HISTORIC AND DESIGN REVIEW COMMISSION

April 19, 2017

HDRC CASE NO: 2017-094
ADDRESS: 121 GLORIETTA
LEGAL DESCRIPTION: NCB 576 BLK 15A LOT E 30 FT OF 10
ZONING: RM-4 H
CITY COUNCIL DIST.: 2
DISTRICT: Dignowity Hill Historic District
APPLICANT: Sylvia Lopez
OWNER: Jasen Lopez
TYPE OF WORK: Replacement of two front windows
REQUEST:

The applicant is requesting a Certificate of Appropriateness for approval to replace the two non-original aluminum windows beneath the front roof gable with new fixed, vinyl windows with divided lights.

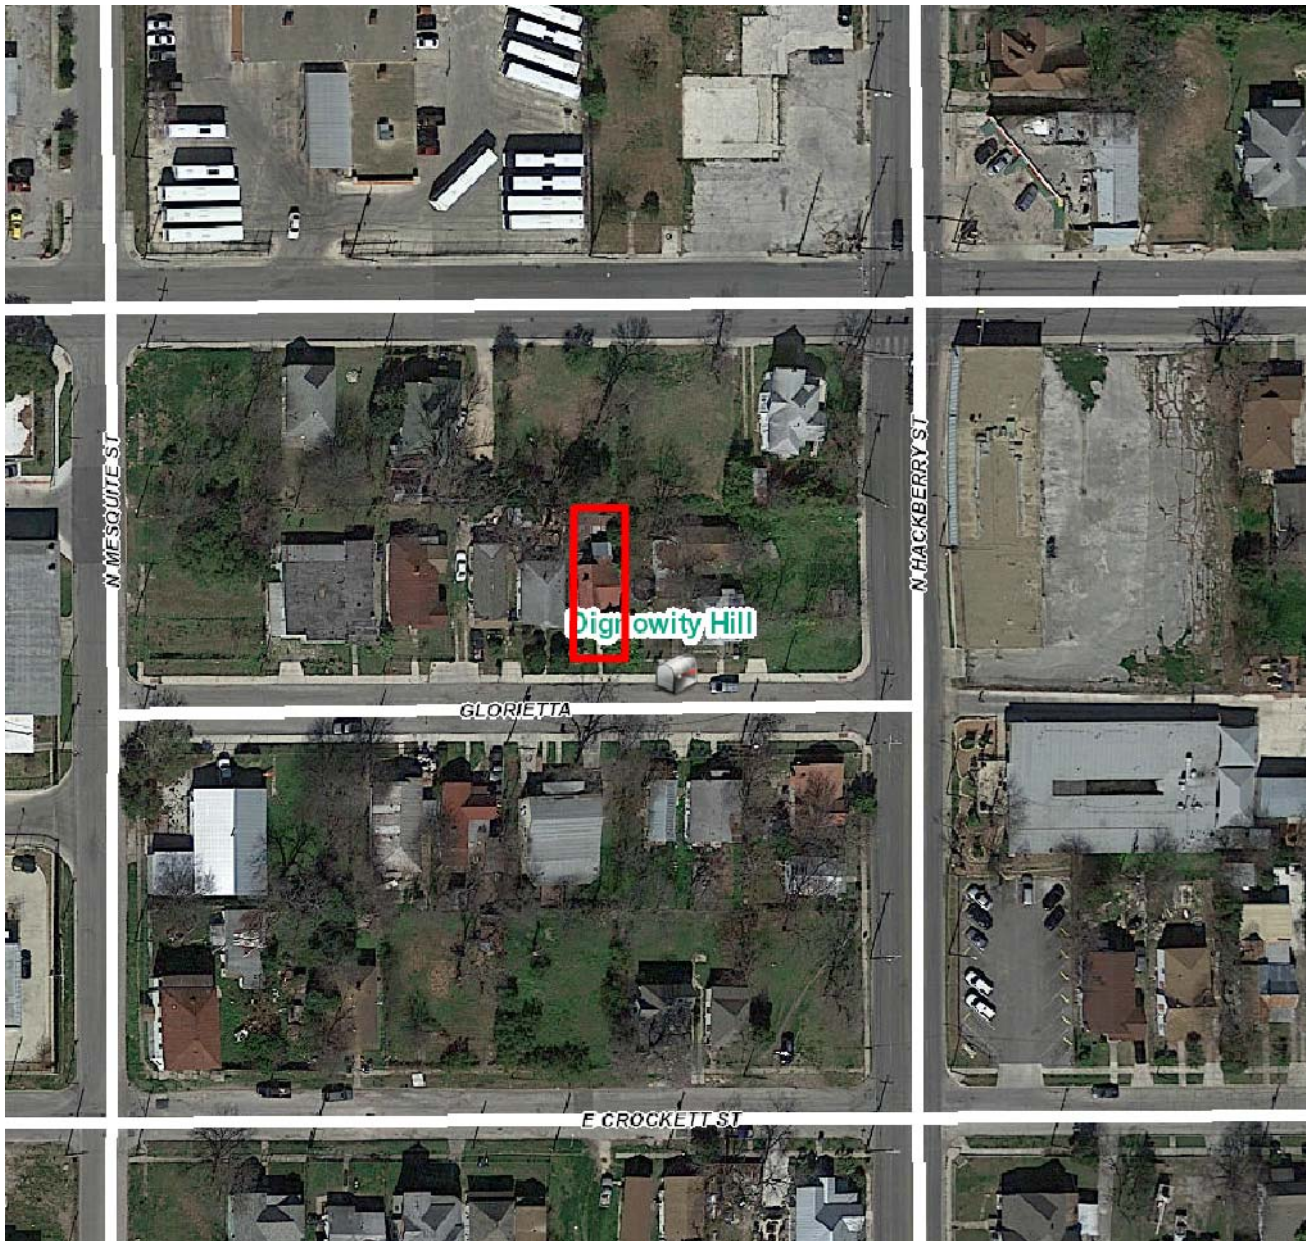
- a. The structure at 121 Glorietta was constructed circa 1910 and features traditional architectural elements including a brick chimney and a standing seam metal roof. The front façade features a recessed front porch and a front facing roof gable. Beneath the roof gable are two window openings that previously features one over one, wood windows. Currently, these openings feature aluminum windows. The applicant has proposed to remove the two aluminum windows and install two new windows that feature a profile that is not historic to this structure, four over four.
- b. Per the Guidelines for Exterior Maintenance and Alterations 6.B.vii., non-historic windows should be replaced with windows that are typical of the architectural style of the building. Staff finds that a wood window with a one over one profile is architecturally appropriate.

Staff does not recommend approval of the proposed replacement windows based on finding b. Staff recommends the applicant install wood, one over one windows, or windows with a historically appropriate profile and configuration.

MARCH 2011 PHOTO

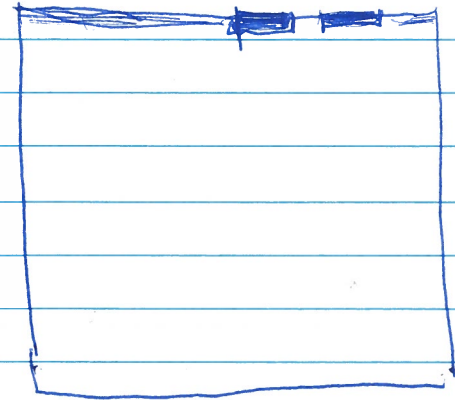
windows
to be
replaced
